City of Lawrence

RE: Report of City Engineer waiver from access management standards in Section 20-915 associated with Minor Subdivision MS-12-9-11, Lawrence Public Library

Attachments: A—Lawrence Public Library Minor Subdivision, MS-12-9-11

Figure 1. Waiver approved for spacing between driveways and spacing between northern 2 driveways on Kentucky Street and W 7th Street. Areas with inadequate spacing are shown in like colors.

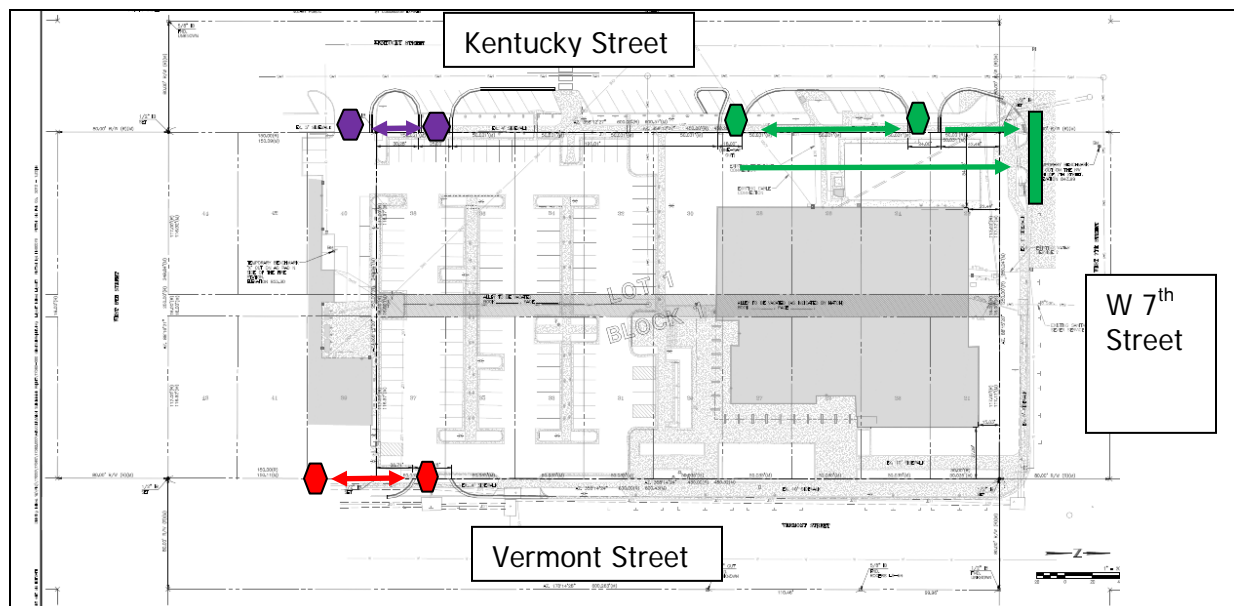
W 7th Street is a local street, therefore the access points on Kentucky and Vermont Streets should be a minimum of 250 ft from the perpendicular curb face of 7th Street. The two northern-most access points on Kentucky Street are approximately 42 ft and 185 ft from the intersection. These access points are not compliant with the Access Management Standards related to separation of driveways from signalized intersections. (Fig. 1)

Section 20-915(e) of the Code also requires driveways providing access to collector streets be constructed so the point of tangency of the curb return radius closest to a non-signalized driveway intersection is at least 250 feet from the perpendicular curb face of the intersecting street or driveway. The 2 northernmost access points on Kentucky Street are approximately 120 ft apart. The southernmost access on Kentucky is approximately 30 ft from the existing access on the property to the south. None of the access points on Kentucky Street comply with the Access Management Standards related to separation of driveways. The access point on Vermont

Street is approximately 65 ft from the access drive serving the Senior Center to the south. The driveways on Kentucky and Vermont Streets are not compliant with the Access Management Standards related to separation of driveways from other driveways on Collector Streets. (Fig.1)

The City Engineer approved the requested waiver for the spacing of the Kentucky Street access points based on the fact that the waiver would not create a serious detriment to the safety or operation of traffic on the street for the following reasons:

1. The two driveways off Kentucky and close to 7th street are one-way operation (Enter and Exit only).
2. The two driveways off Kentucky and close to 7th street are one-way operation
3. Kentucky is a one-way street.
4. It does not appear there is any other prudent and feasible alternative to accommodate the Library Master Plan.

The City Engineer approved the requested waiver for the driveway to driveway spacing being proposed along Vermont Street based on the fact that the waiver would not create a serious detriment to the safety or operation of traffic on the street for the following reasons:

1. The driveway off Vermont is an existing driveway and does not seem feasible to close or relocate.
2. It does not appear there is any other prudent and feasible alternative to accommodate the Library Master Plan.
